ADDENDUM

NO. 1

PROJECT NAME: Early Learner's Academy 2

ADDENDUM DATE: June 19, 2025

1 FOUNDATION PLAN - AREA E
S2.12 1/8" = 1'-0"

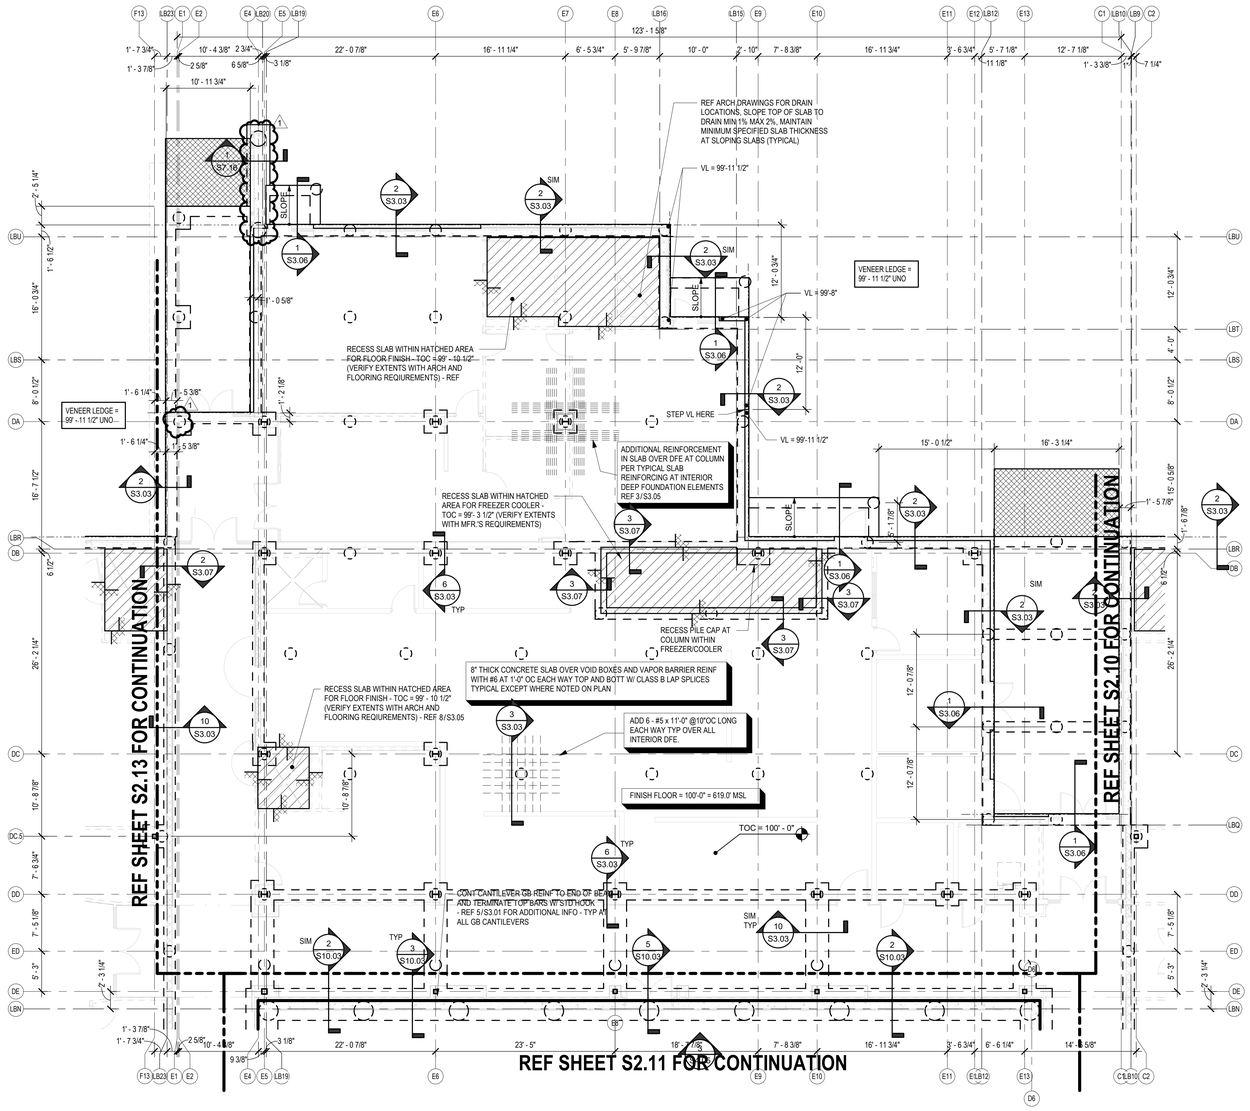
AD No 1, Struct Item 11: To the Drawings, Sheet S2.12, "FOUNDATION PLAN - AREA E"
Revisions and clarifications as follows:
1) HSS5x5x1/4 column along gridline E2 removed.
2) W12x72 column along gridline E4 removed.

1 FOUNDATION PLAN - AREA F
S2.13 1/8" = 1'-0"

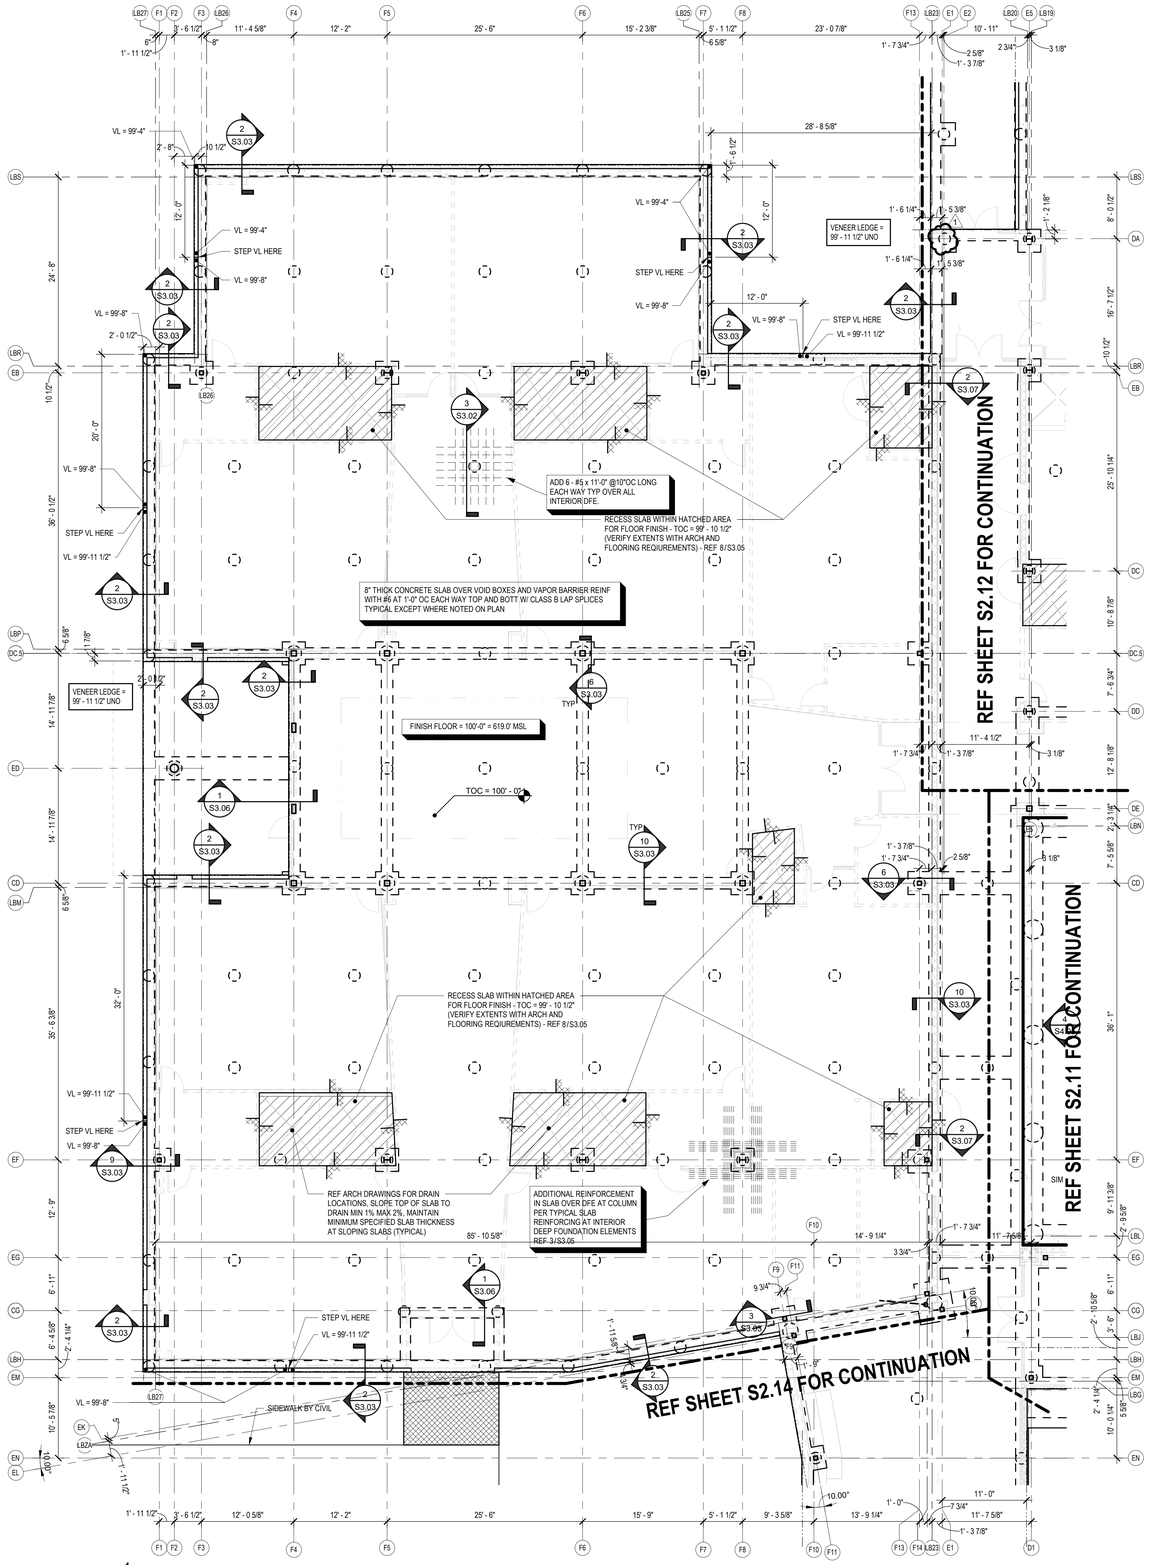
AD No 1, Struct Item 12: To the Drawings, Sheet S2.13, "FOUNDATION PLAN - AREA F"
Revisions and clarifications as follows:
1) HSS5x5x1/4 column along gridline E2 removed.

1 ANCHOR ROD PLACEMENT PLAN - AREA A
S2.15 1/8" = 1'-0"

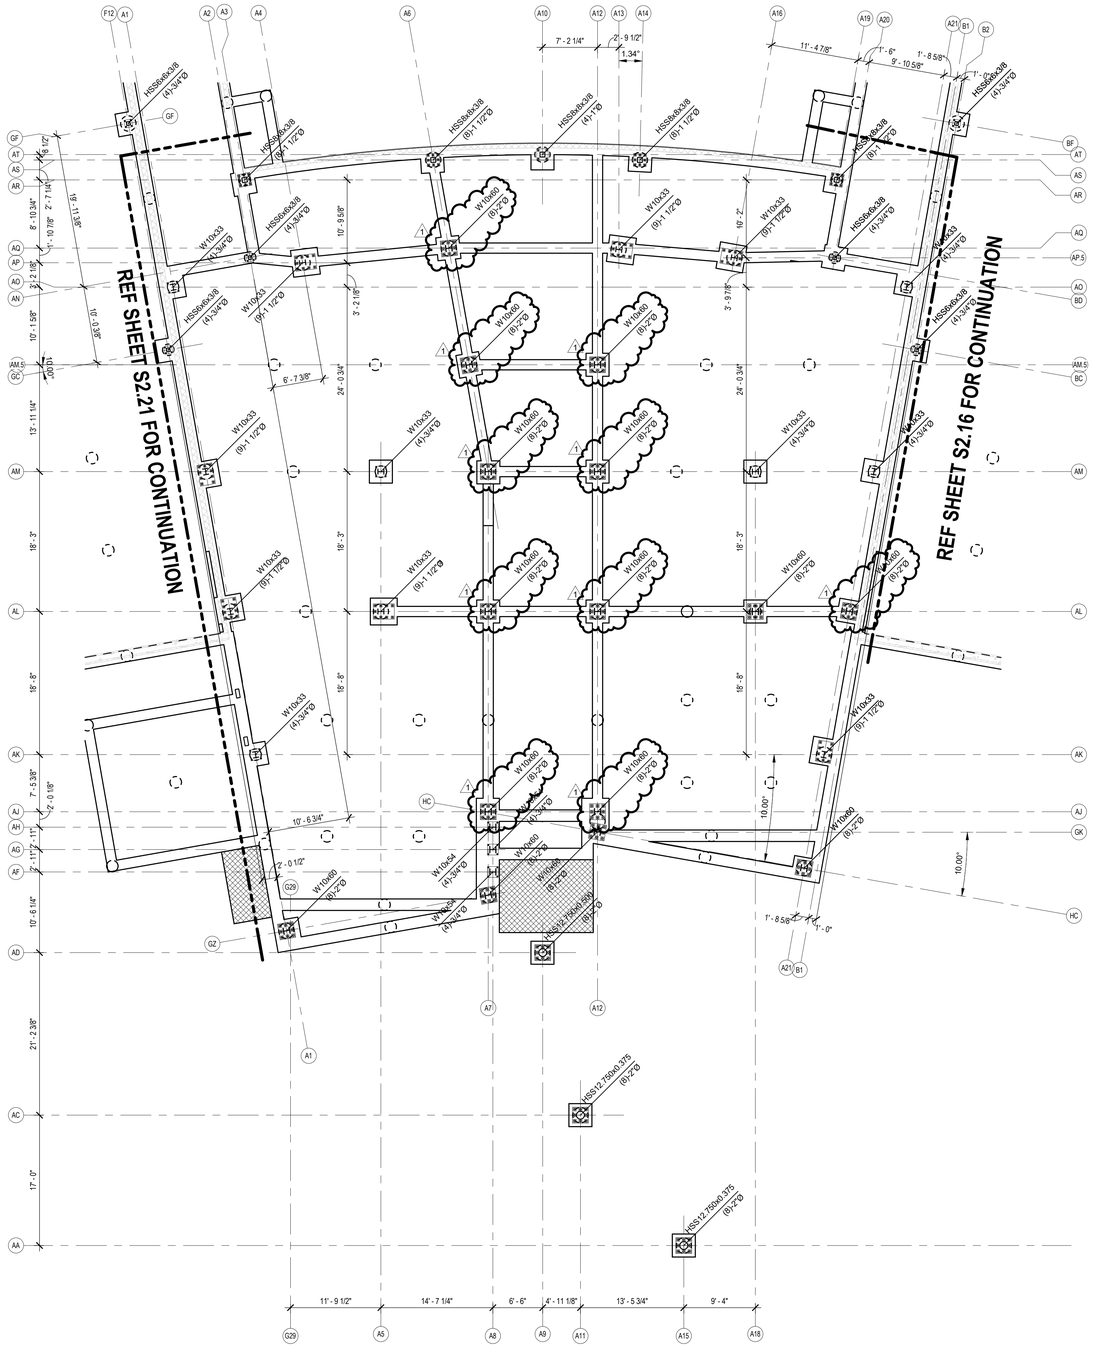
AD No 1, Struct Item 13: To the Drawings, Sheet S2.15, "ANCHOR ROD PLACEMENT PLAN - AREA A"
Revisions and clarifications as follows:
1) Additional baseplates detailed and labeled.
2) W10x60 columns rotated.
3) Baseplates rotated.

1 ANCHOR ROD PLACEMENT PLAN - AREA E
S2.19 1/8" = 1'-0"

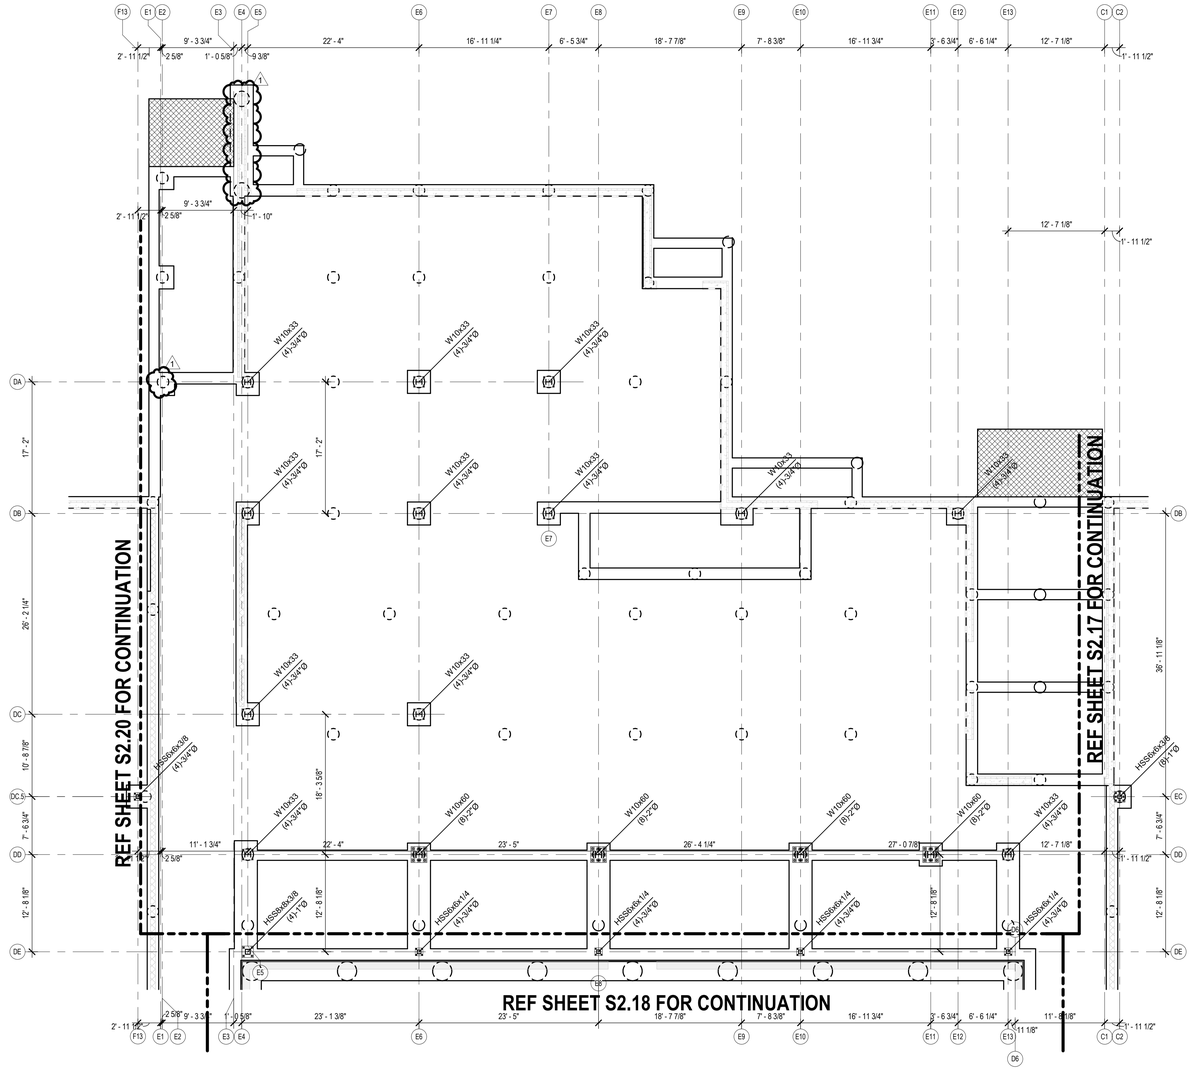
AD No 1, Struct Item 15: To the Drawings, Sheet S2.19, "ANCHOR ROD PLACEMENT PLAN - AREA E"
Revisions and clarifications as follows:
1) HSS5x5x1/4 column and baseplate along gridline E2 removed.
2) W12x72 column and baseplate along gridline E4 removed.

1 ANCHOR ROD PLACEMENT PLAN - AREA F
S2.20 1/8" = 1'-0"

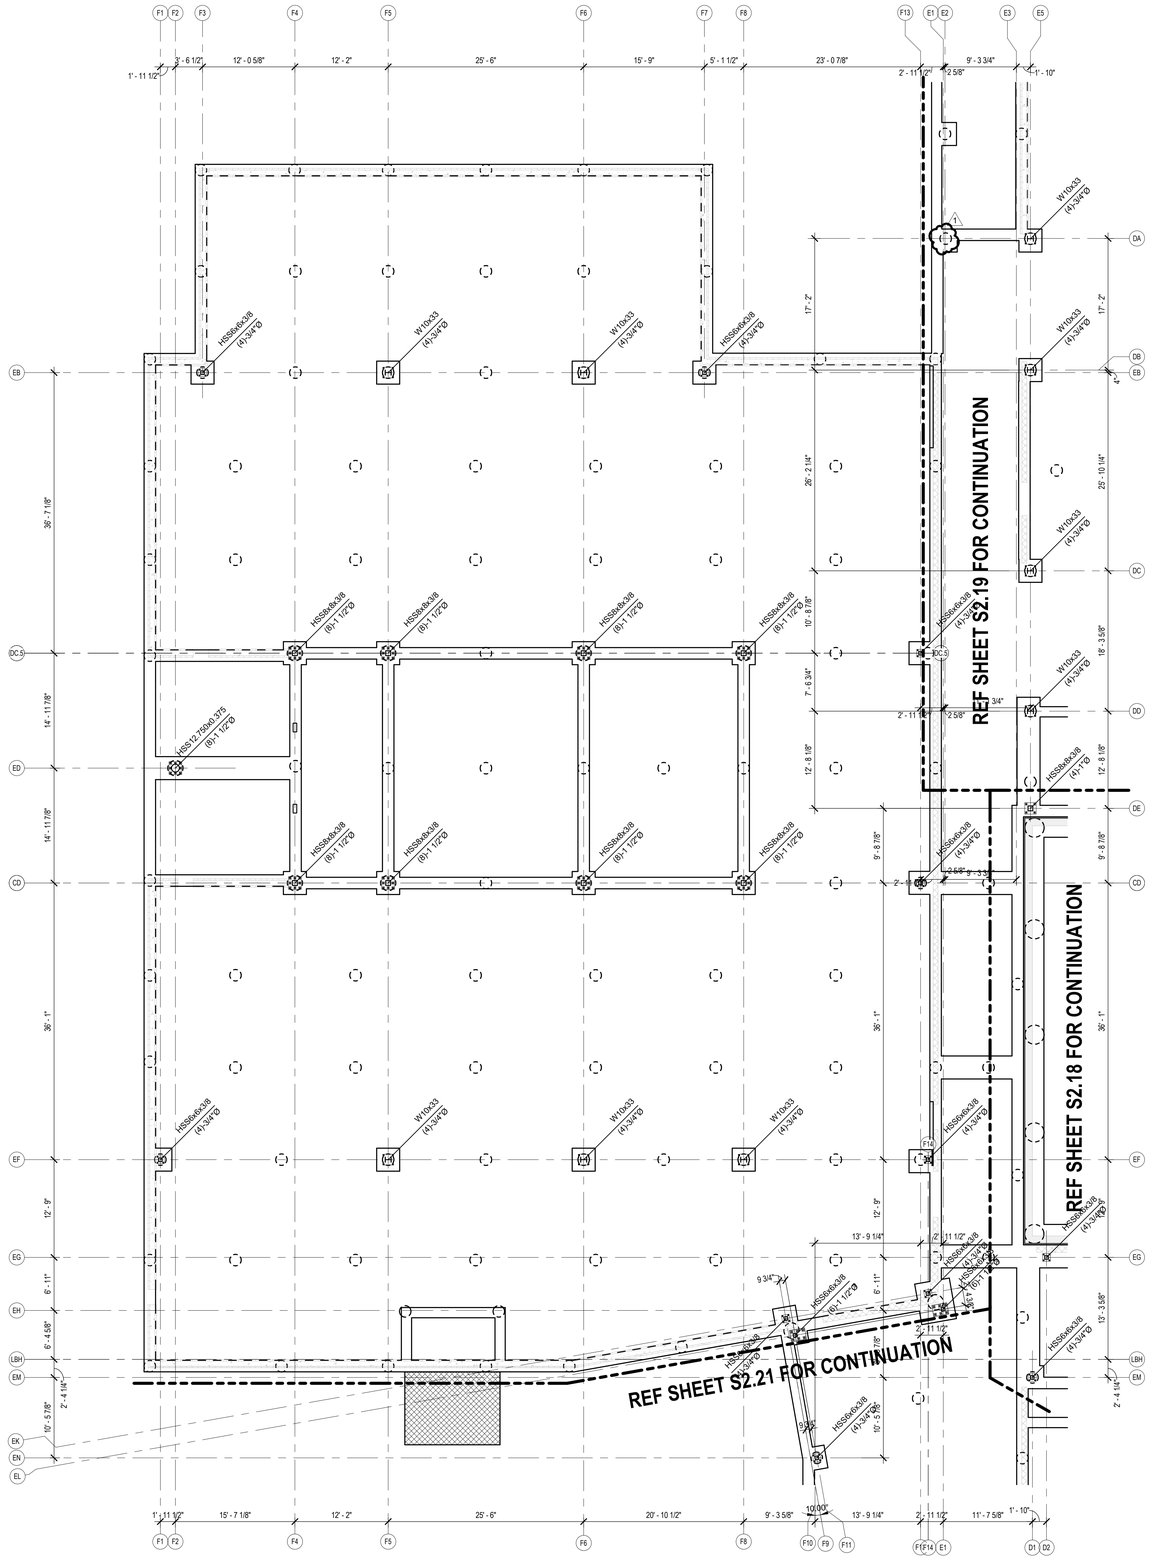
AD No 1, Struct Item 16: To the Drawings, Sheet S2.20, "ANCHOR ROD PLACEMENT PLAN - AREA F"
Revisions and clarifications as follows:
1) HSS5x5x1/4 column and baseplate along gridline E2 removed.

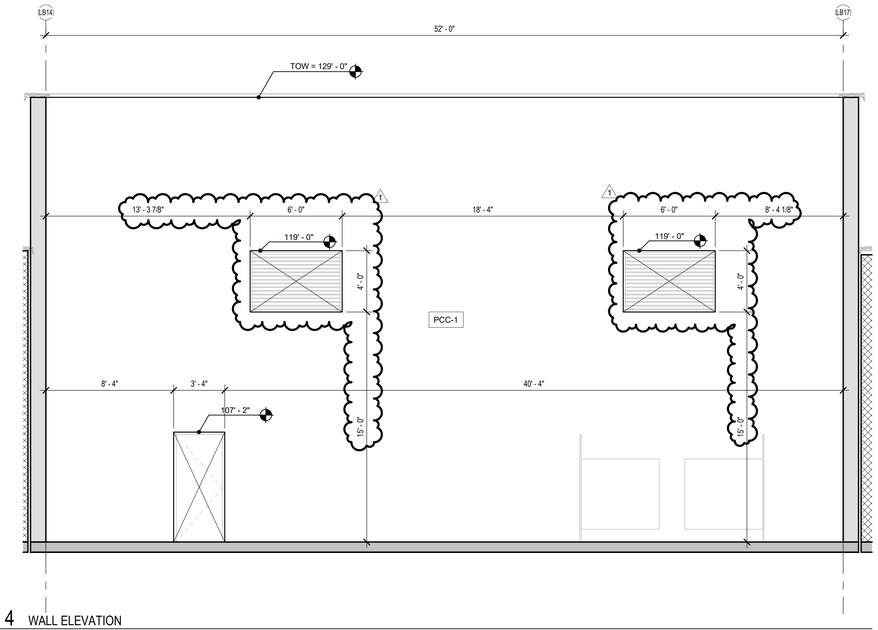
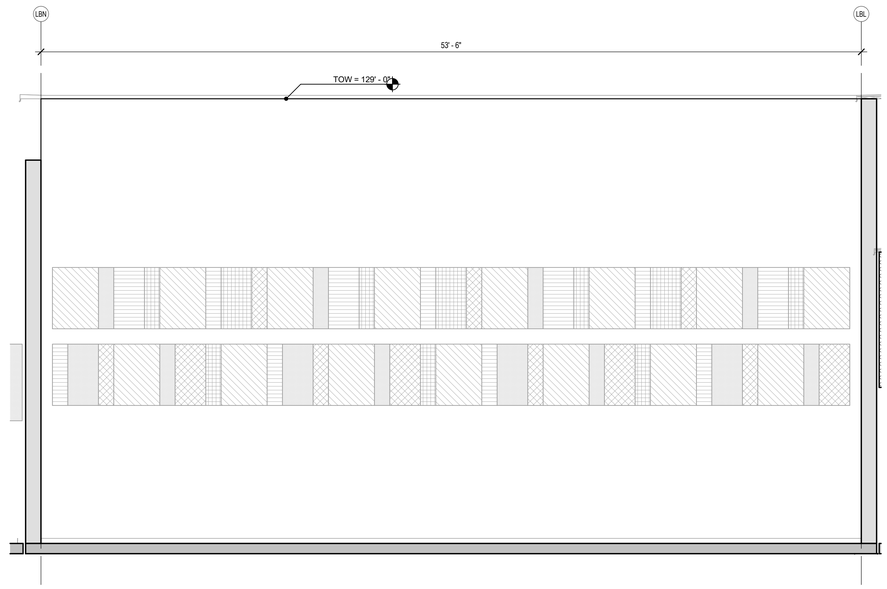
AD No 1, Struct Item 17: To the Drawings, Sheet S4.06, "WALL ELEVATIONS"
Revisions and clarifications as follows:
1) Openings dimensions/position adjusted to match architectural drawings.

1 ROOF FRAMING PLAN - AREA A
S6.01 1/8" = 1'-0"

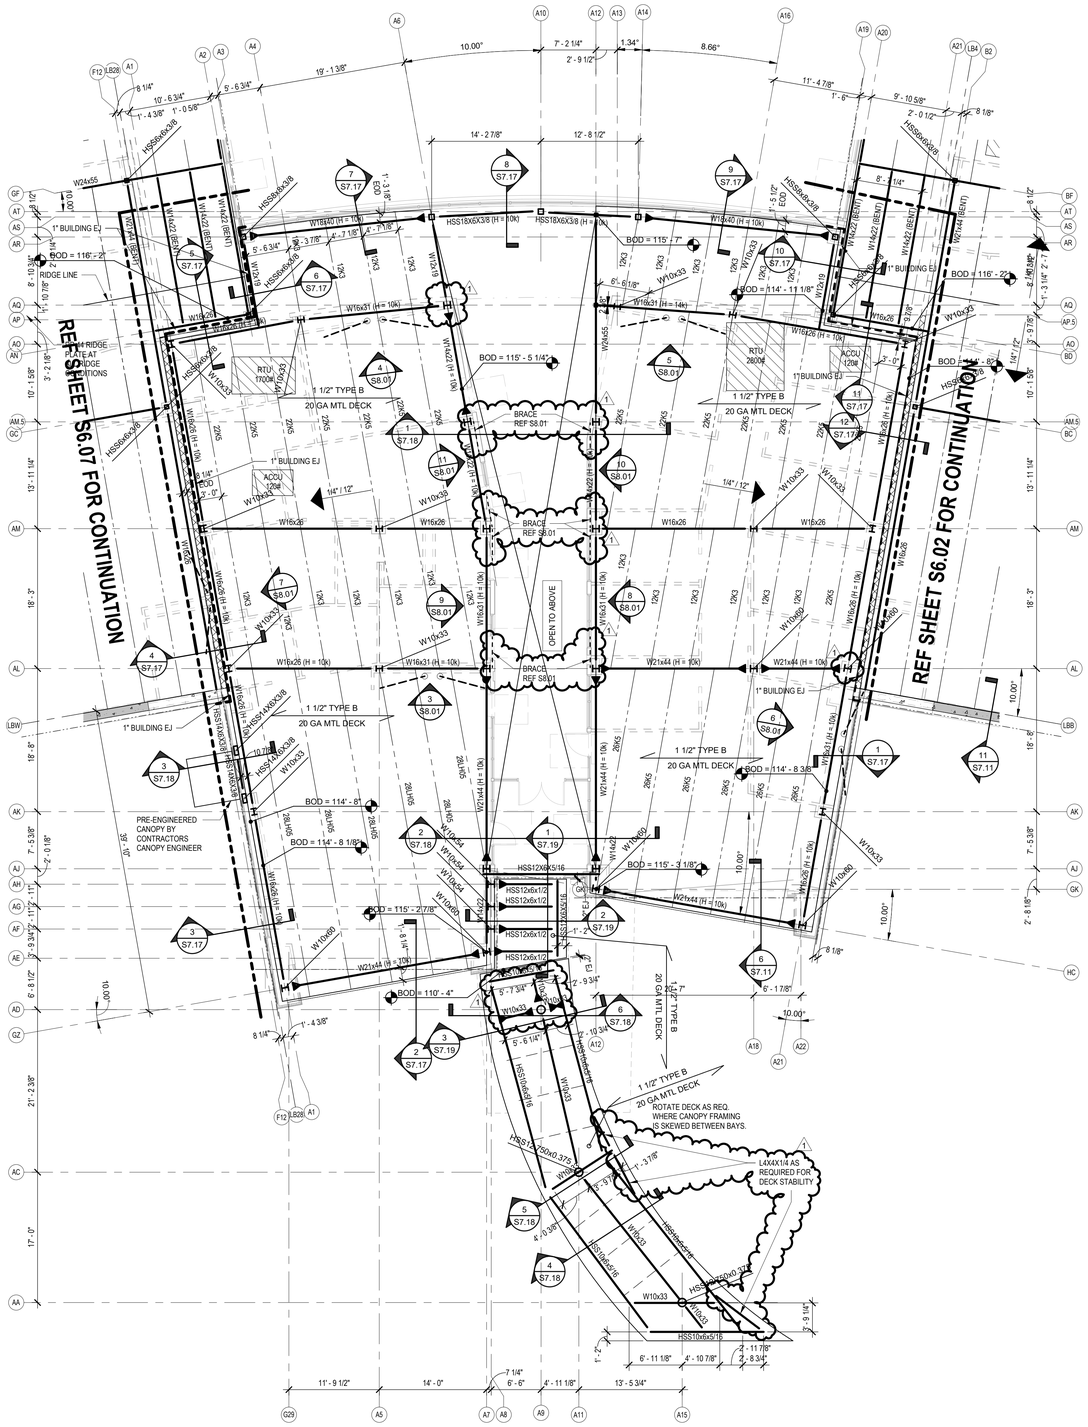
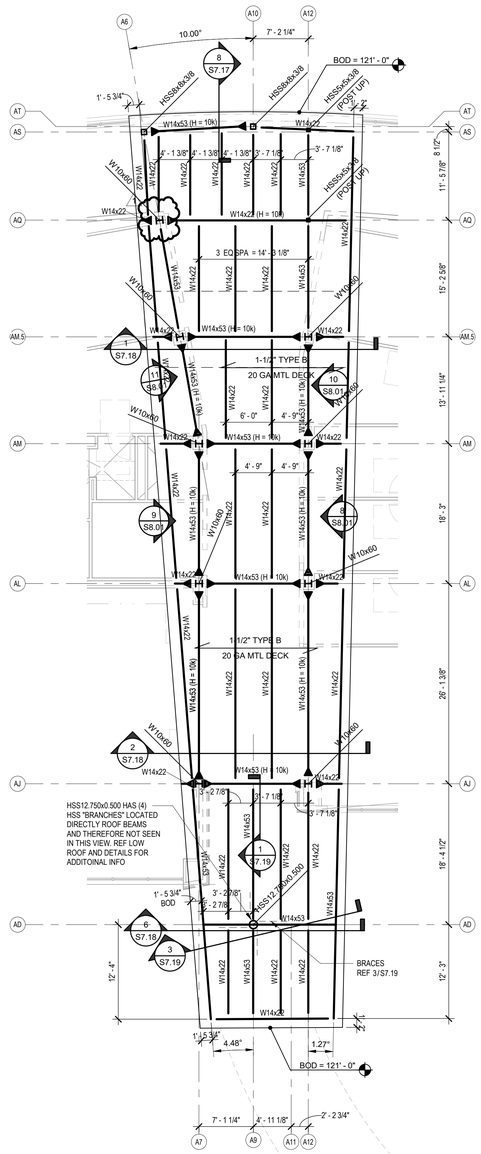
AD No 1, Struct Item 18: To the Drawings, Sheet S6.01, "ROOF FRAMING PLAN - AREA A"
Revisions and clarifications as follows:
